CAVENDISH ER BRF 0146 (13)
CONTRACTOR FABRICATED PBU UNITS

SHEET1:PBU PLAN
SHEET2:PBU PLAN UNITS 1&2
SHEET3:PBU PLAN UNITS 3&4
SHEET4:PBU TYPICAL DETAILS
SHEET5:CLOSURE POUR DETAILS
SHEET6:PBU INSERT-LAYOUT
SHEET7:PBU-RE-BAR
SHEET8:QC PROCEDURES/PLAN
SHEET9:QC PROCEDURES/PLANS
SHEET10:PBU CASTING PLAN
SHEET11: CONCRETE MIX DESIGNS
SHEET12: BRIDGE ANCHORAGE
(ADDED 2-19-14)

(REVISION #1 2/17/2014)

DECK REINF PLAN

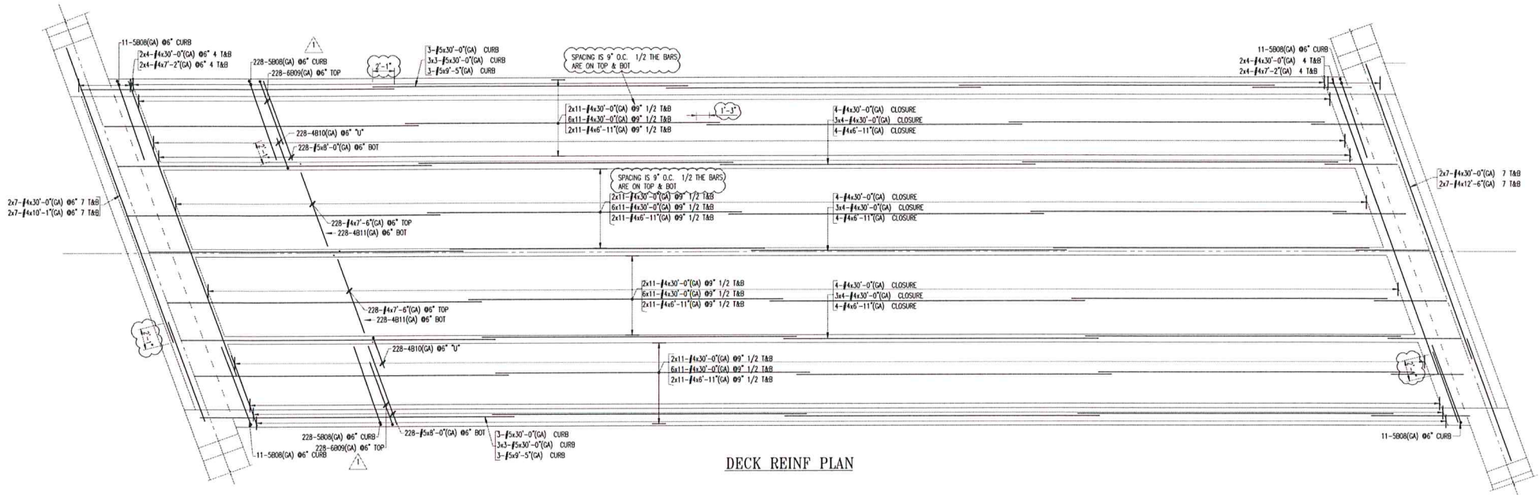
FOR THE B901 & B902 THE ONLY DIMENSIONS THAT CAN CHANGE IS THE "B" DIMENSION. THE "A" & "J" ARE THE STANDARDS FOR THE BAR SIZE THE 6" "J" DIMENSION IS TO SMALL TO BEND. PLEASE VERIFY IT IS OK TO LEAVE AS IS.

ENG. AND ARCH. PLEASE VERIFY ALL CLOUDED AREAS

CASTING BED

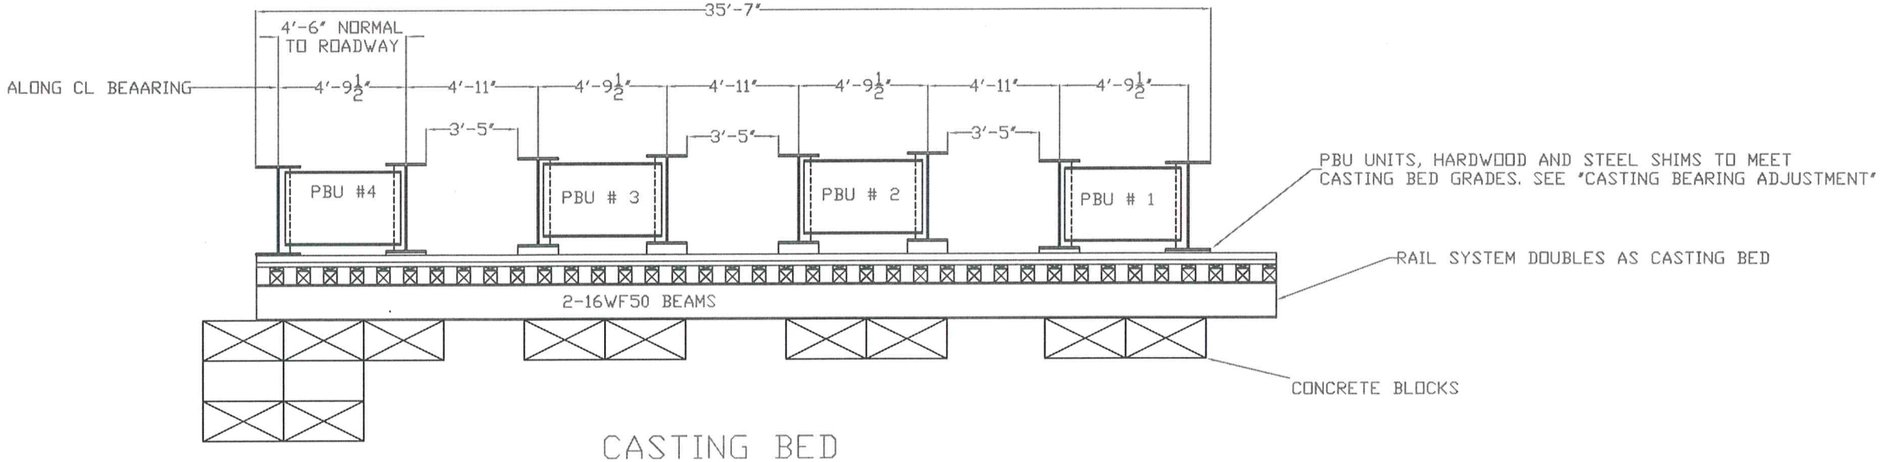
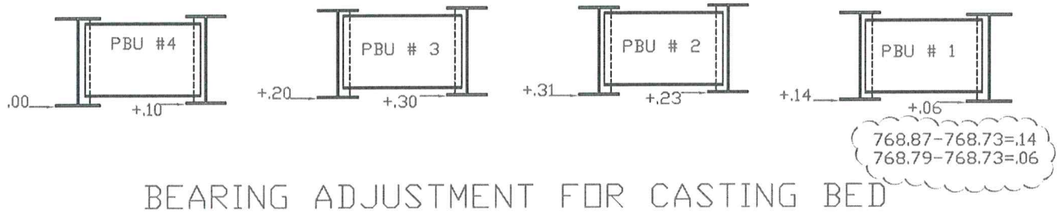
****THEORETICAL BOTTOM OF DECK ELEVATIONS ARE NOT INCLUDED IN THE PLANS,PLEASE PROVIDE.PLEASE PROVIDE ELEVATIONS BASED ON FINAL LOCATION.
